Subject: **Presentation of a Conceptual Plan for Roberts Drive Improvements at the New Austin Elementary School**

ROBERTS DRIVE IMPROVEMENTS AT NEW AUSTIN ELEMENTARY SCHOOL

ROBERTS DRIVE IMPROVEMENT CONCEPT

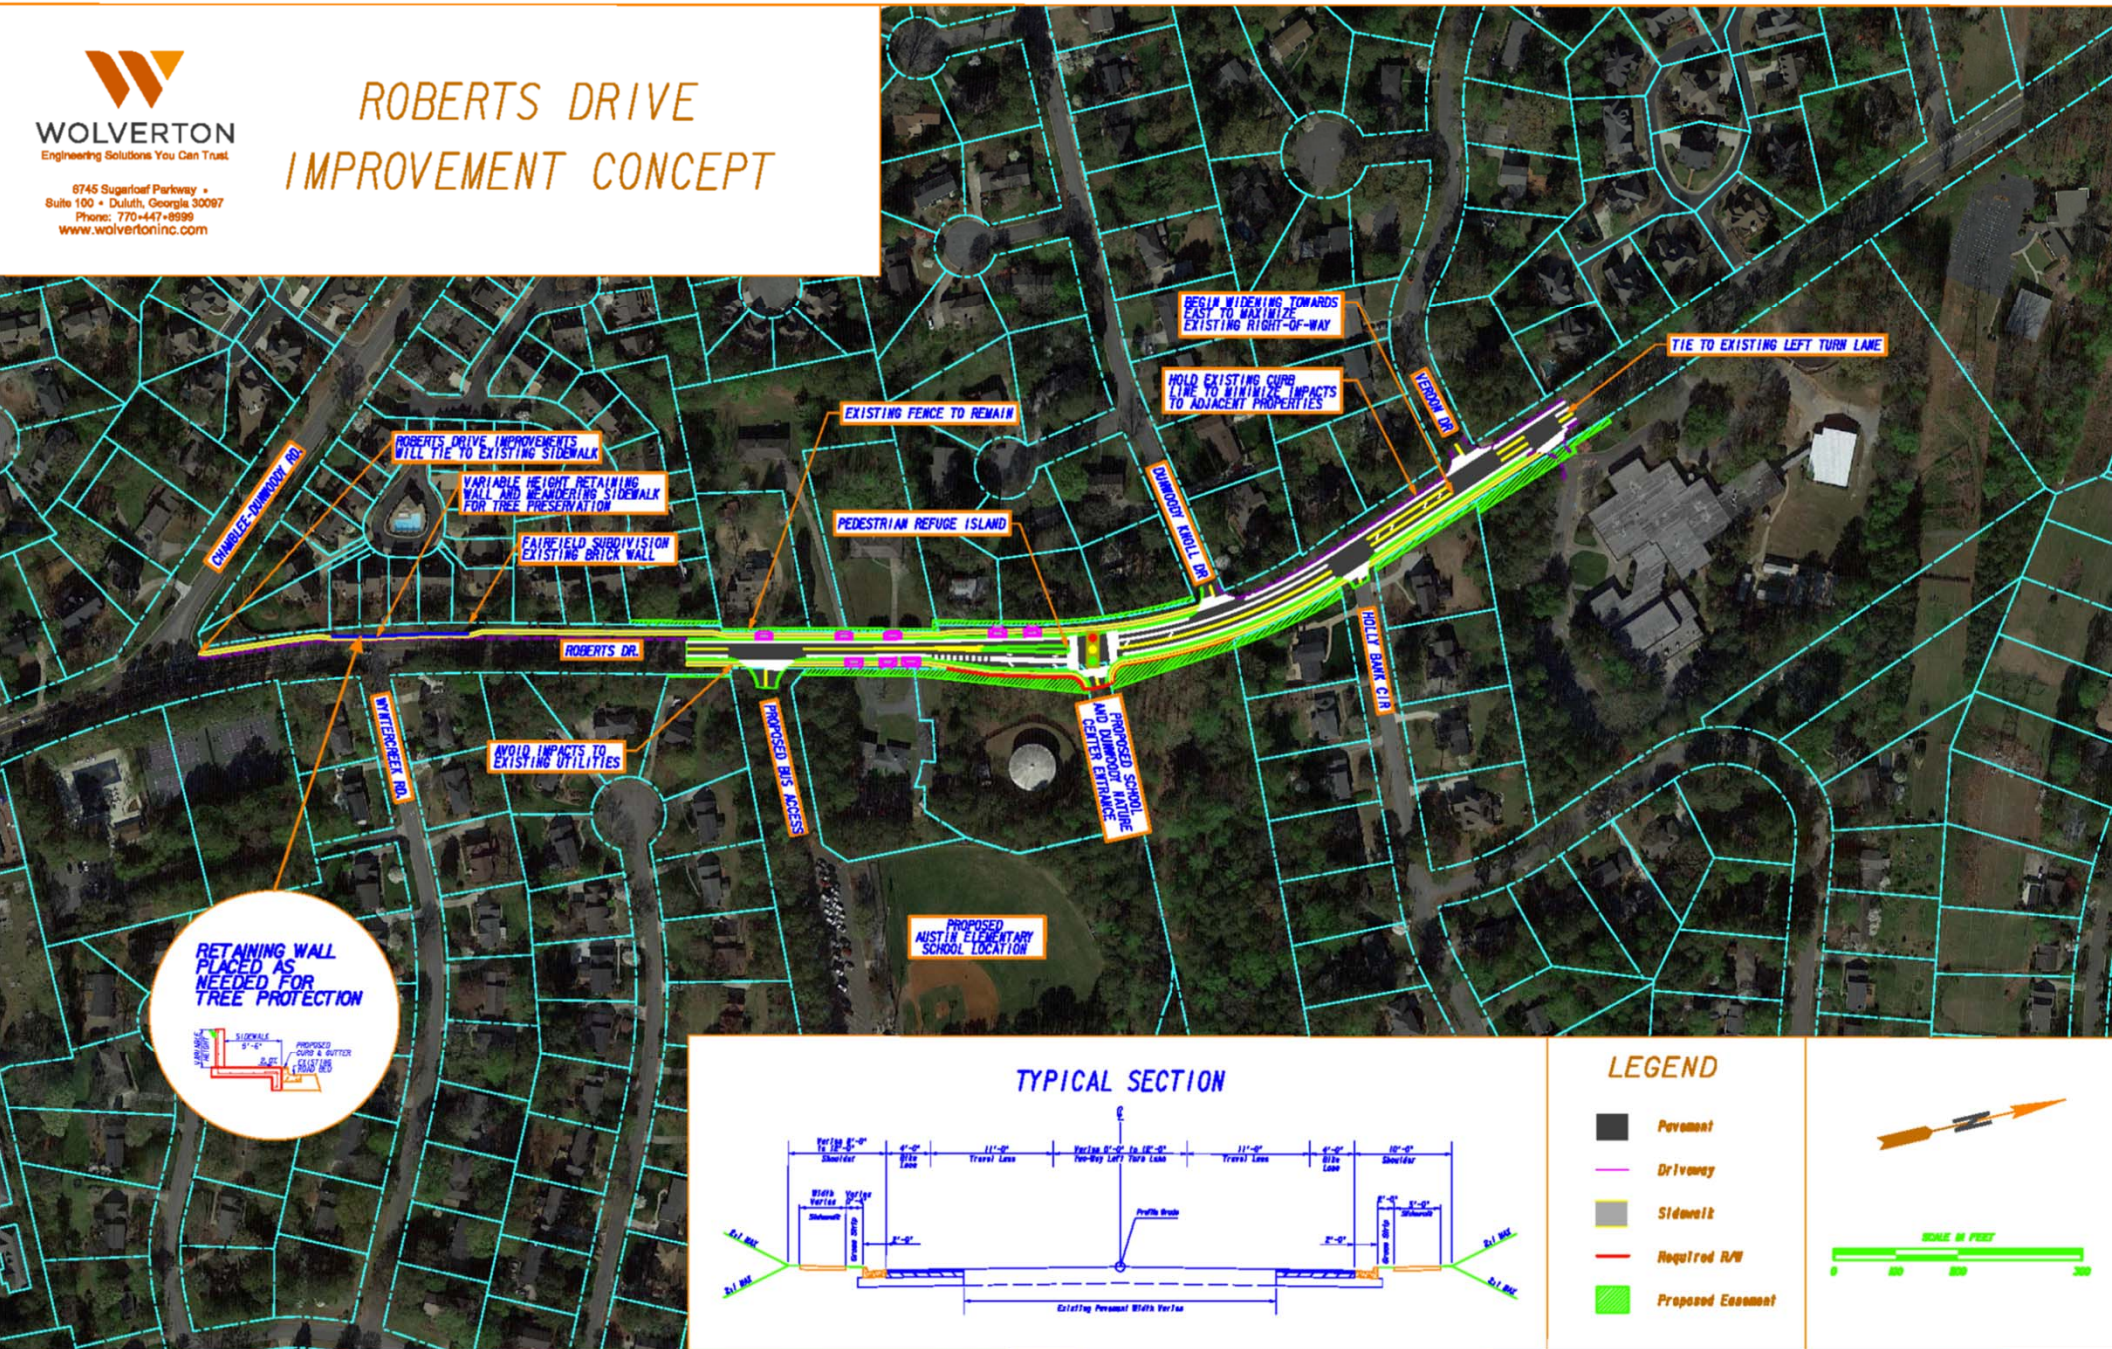
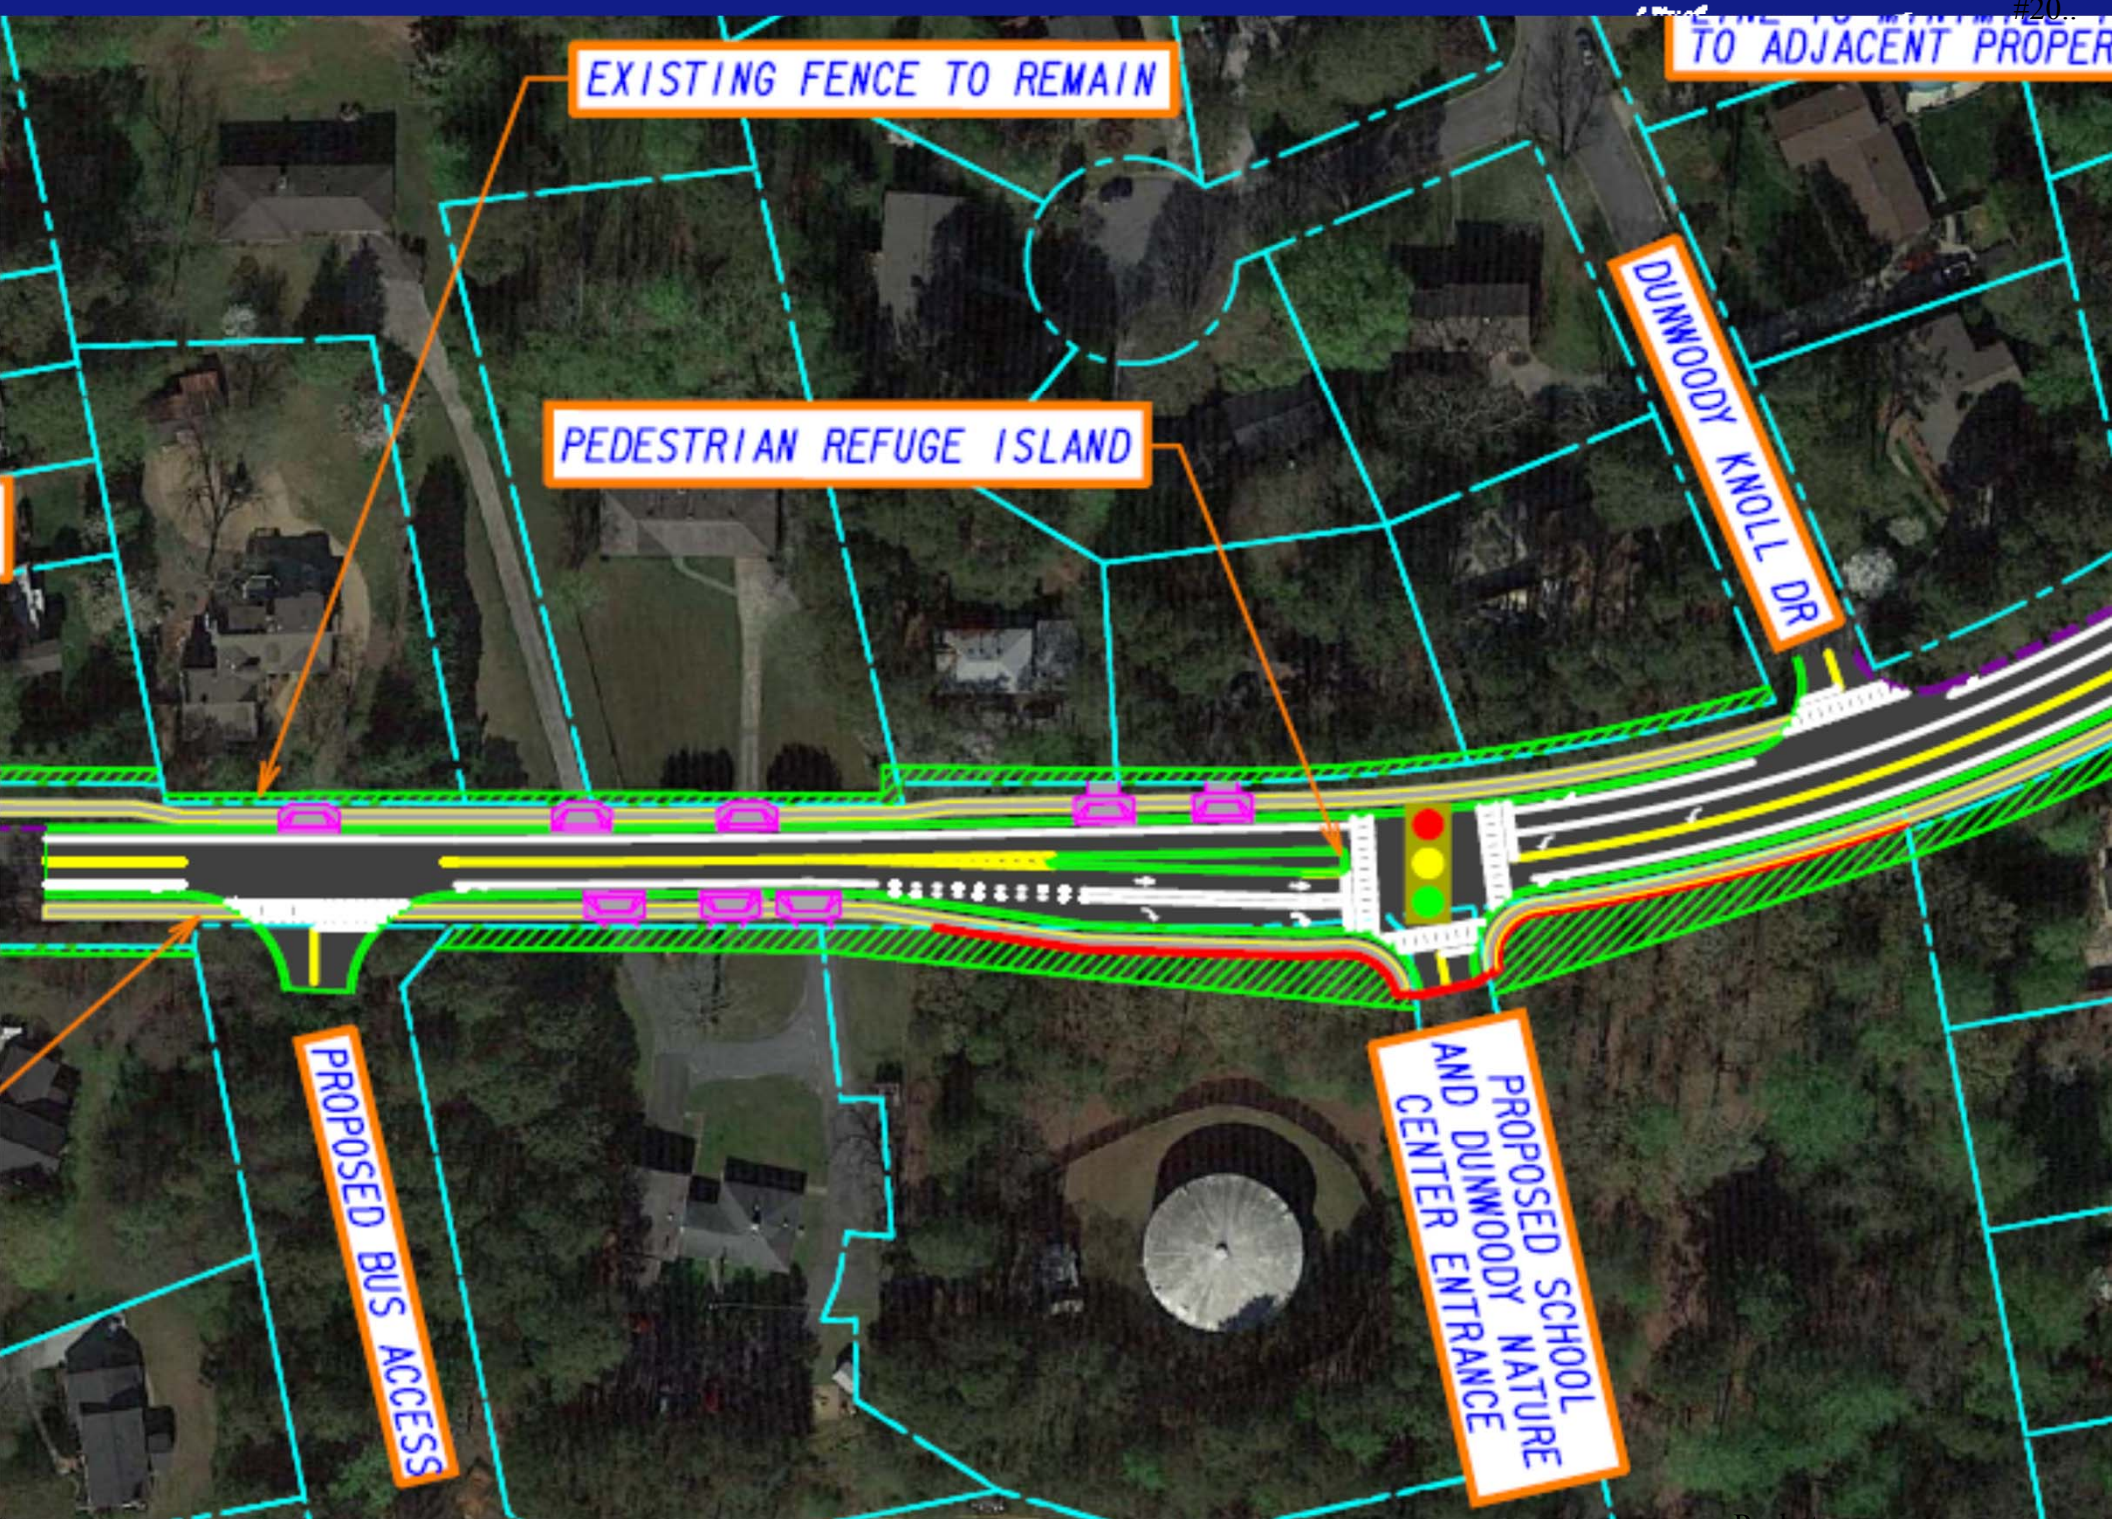
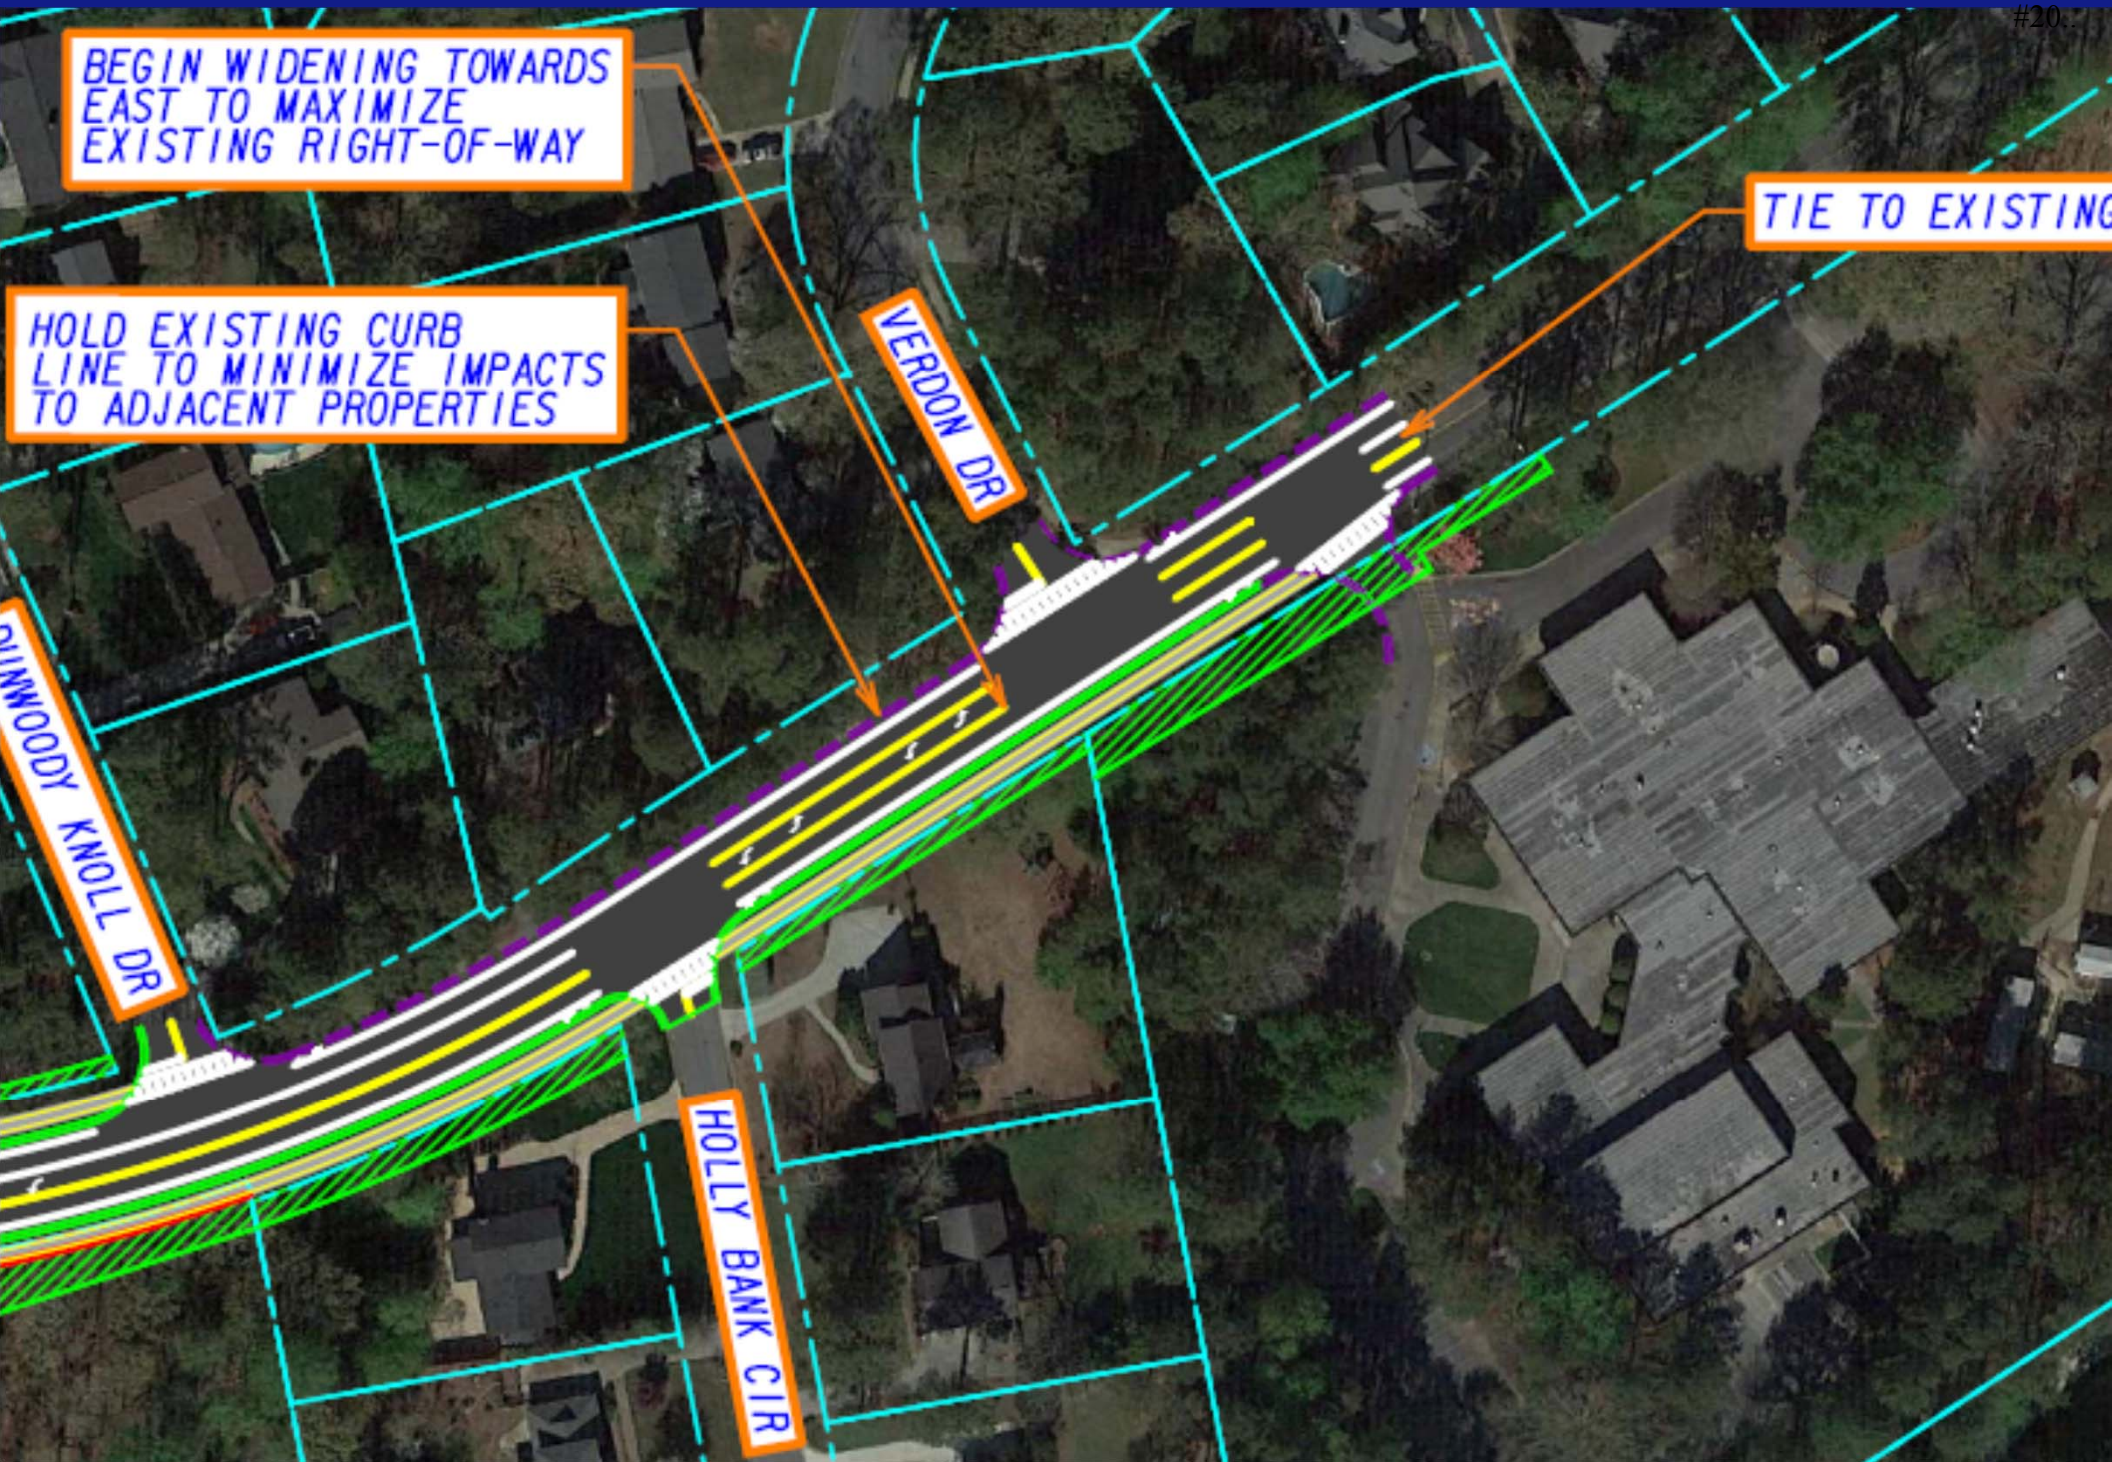
- Consider mature trees along proposed Sidewalk on West Side
- Encourage Walking to School with Wide Sidewalks Separated From the Roadway on Both Sides
- Existing Sidewalk Between the School and Wyntercreek is Narrow and Close to Road

- Right Turn Lane into School May Need to be Longer
- Add Right Turn Lane for School Driveway
- Can Signal Timing Accommodate Special Events at School or Nature Center
- Work with Nature Center to Landscape Entrance

- Land Survey and Detailed Design
- Work with Arborist to Assess and Protect Trees Along Proposed Sidewalk Extension to Chamblee Dunwoody
- Develop Cost Estimate and Fully Fund Construction
- Right of Way Acquisition
- Utility Coordination
- Complete Construction by August 2019
